**MAPLE ROAD TH 317B
BASE ADDITION AND PRIME COAT
SHEFFIELD, OHIO**

**TO PROSPECTIVE BIDDERS
JUNE 29, 2026
ADDENDUM NO. 1**

2	ASHTABULA COUNTY ENGINEERING DEPARTMENT	TYPICAL SECTION & CALCULATIONS	SCALE:	DRAWN: JNC
3	TIMOTHY T. MARTIN-COUNTY ENGINEER		DATE: 6/29/26

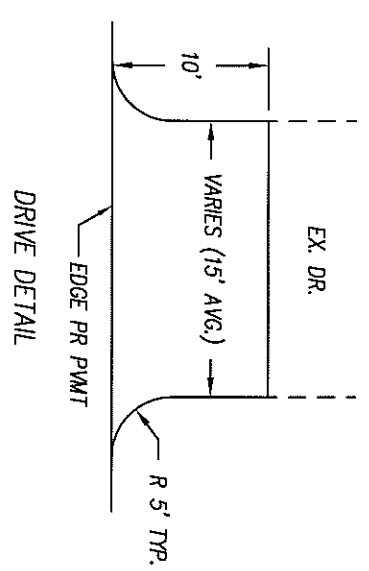
The Quantity for Item 408 Cover Aggregate was in error.

Item 408 Cover Aggregate is 77 Cu. Yds.

Please replace Page 2 in the plans and the Proposal Sheet with the attached sheets.

ITEM 408 COVER AGGREGATE INCLUDING DRIVES 15,450 SQ. YDS. (12) = 185,400 LBS. / 2430 = 77 CU YDS.
